PRODUCT CHANGE NOTIFICATION

Bourns® Model PTV09A-5 Panel Controls

Design Change

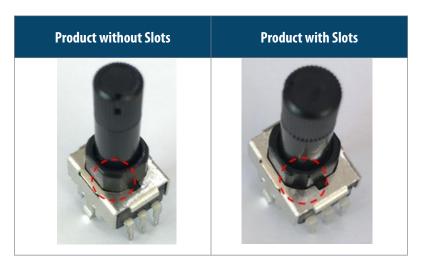
Riverside, CA – January 20, 2020 – Effective immediately, Bourns is adding two slots to the corner bushing of the Model PTV09A-5 Panel Controls. This change is being implemented by customer request to improve the product's application adaptability, and to standardize bushings.

This change will have no effect on the fit, function, quality or reliability. The product's form will change at the bushing corner.
